**RE: Nobis Rehab Hospital
1100 Woodward Pl. NE
Conceptual Grading Plan
Engineer's Stamp Date: 10/03/2024
Hydrology File: J15D053**

PO Box 1293
Albuquerque
NM 87103
Based upon the information provided in your submittal received 10/04/2024, the Conceptual Grading Plan is preliminarily approved for action by the Development Facilitation Team (DFT) on the Site Plan for a Building Permit.

GR-1

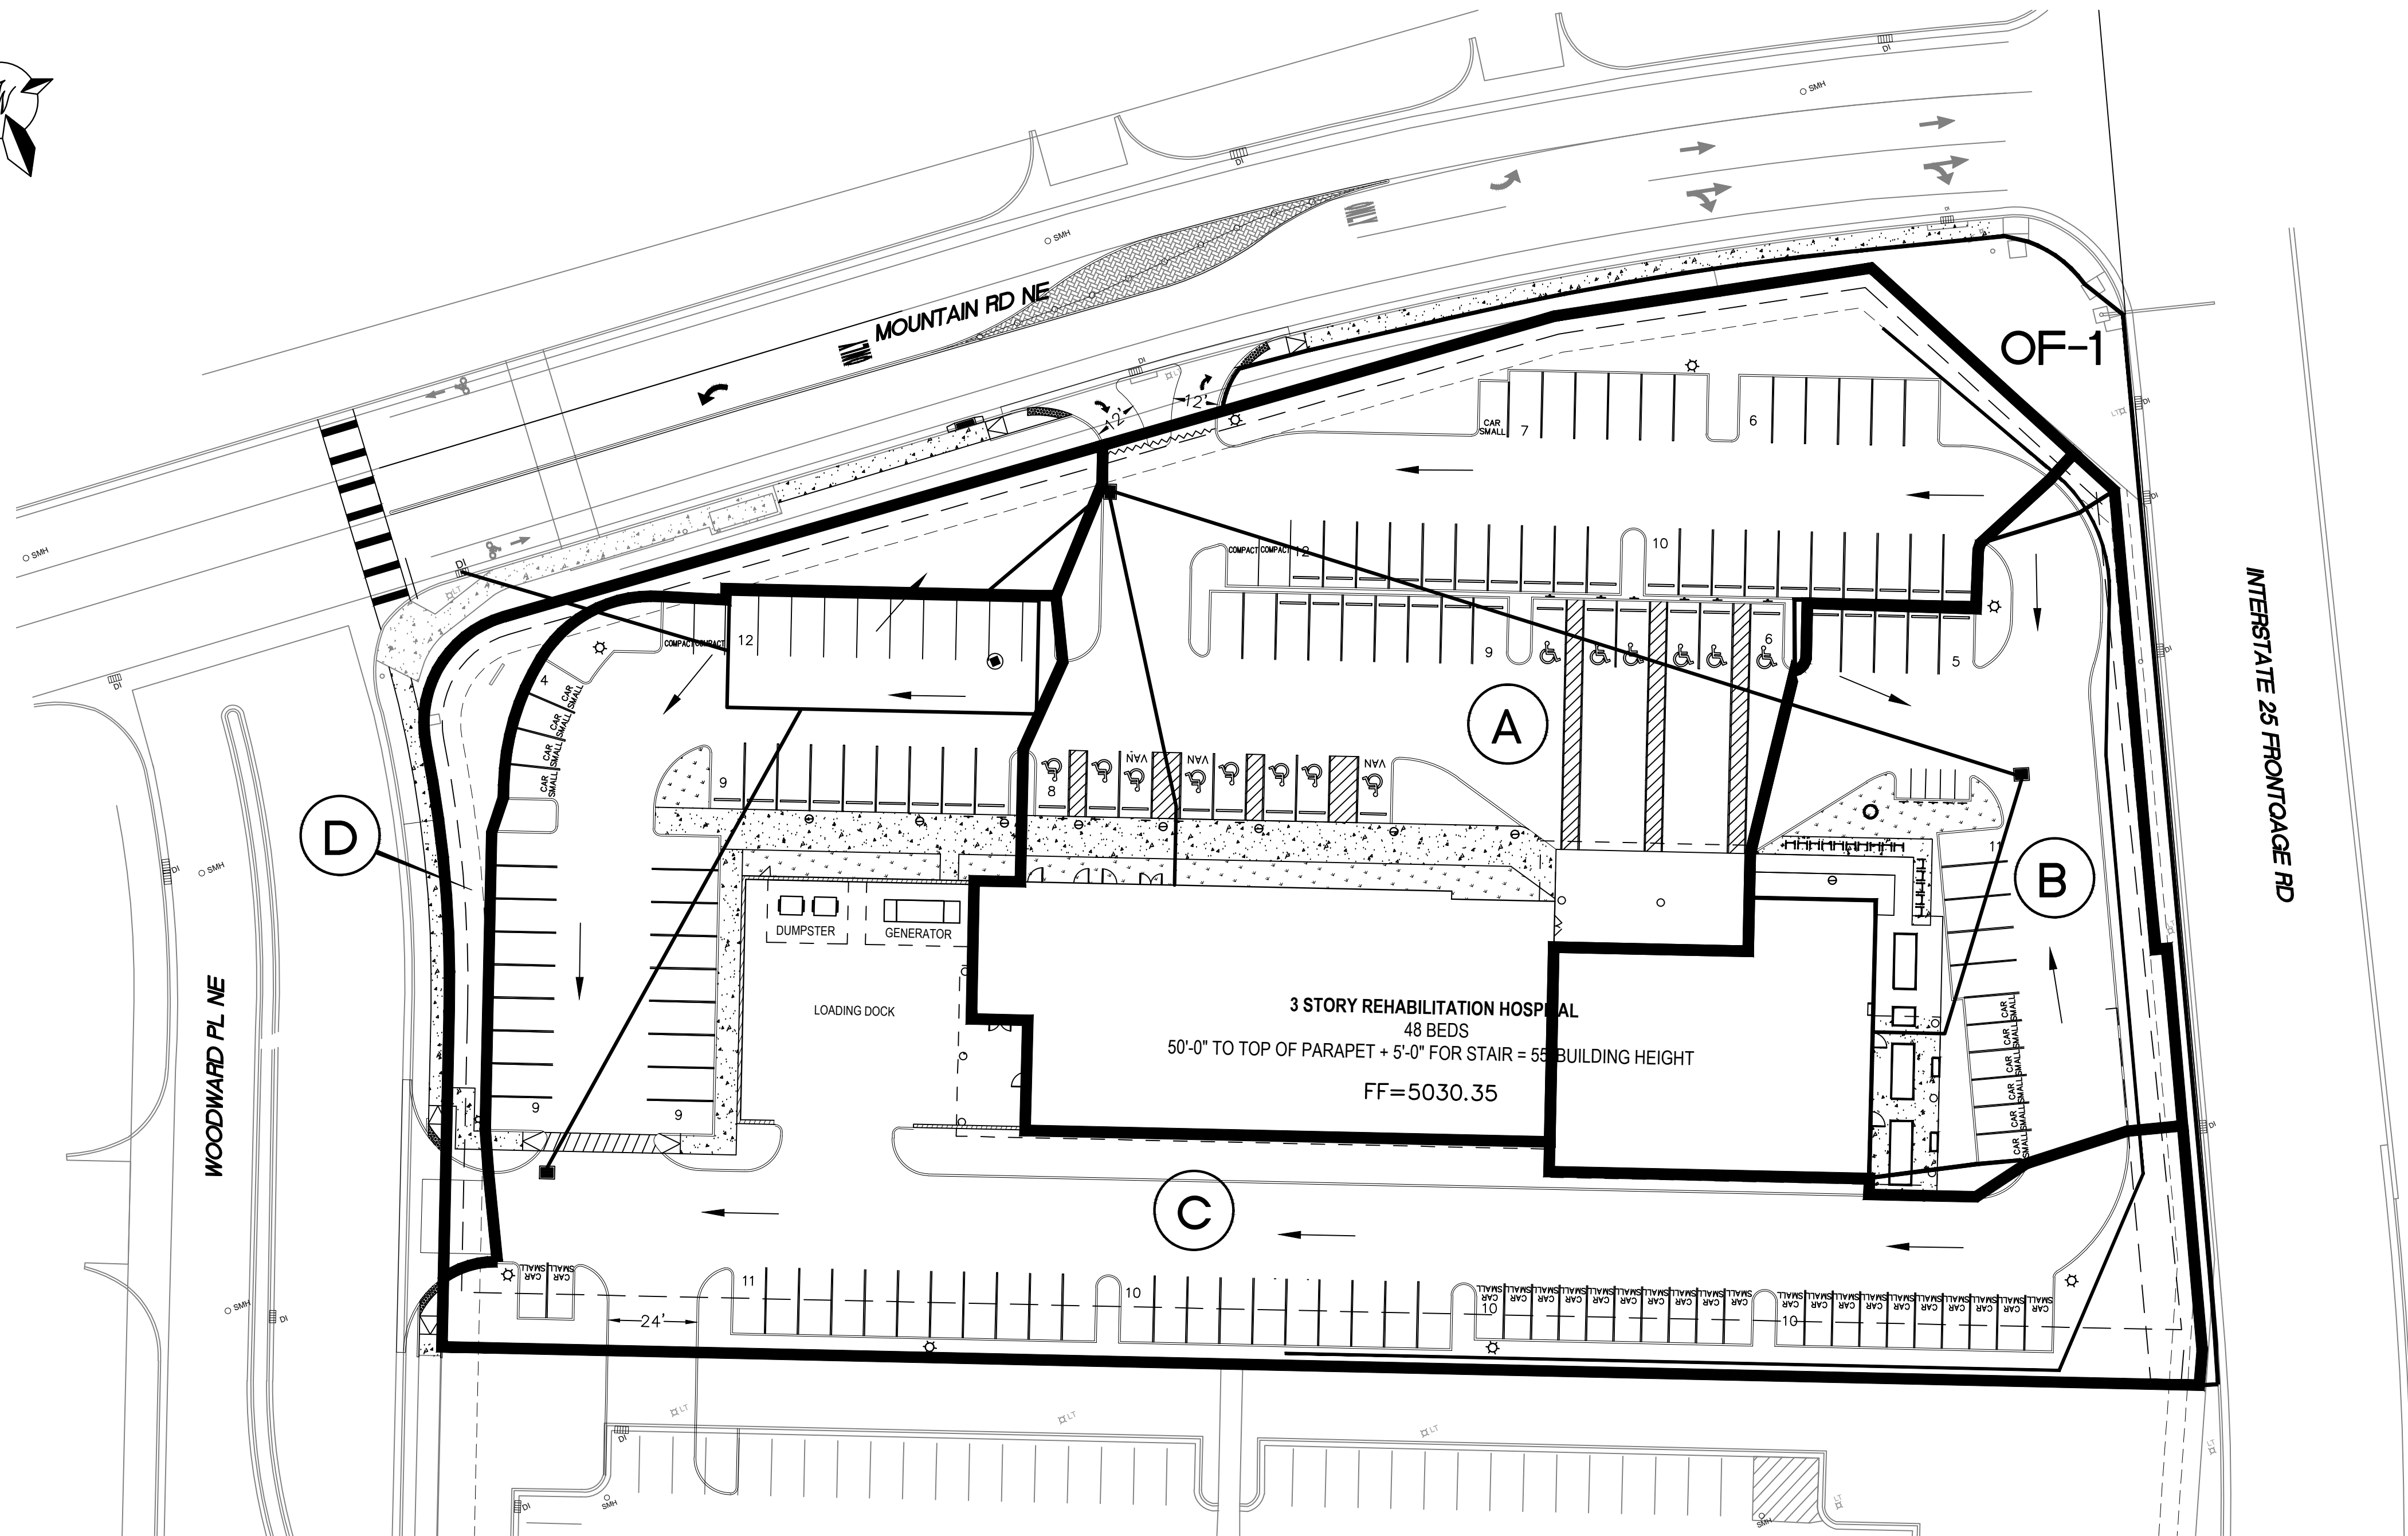
1. Please submit a more detailed Grading & Drainage Plan to Hydrology for review and approval. This digital (.pdf) is emailed to PLNDRS@cabq.gov along with the Drainage Transportation Information Sheet.
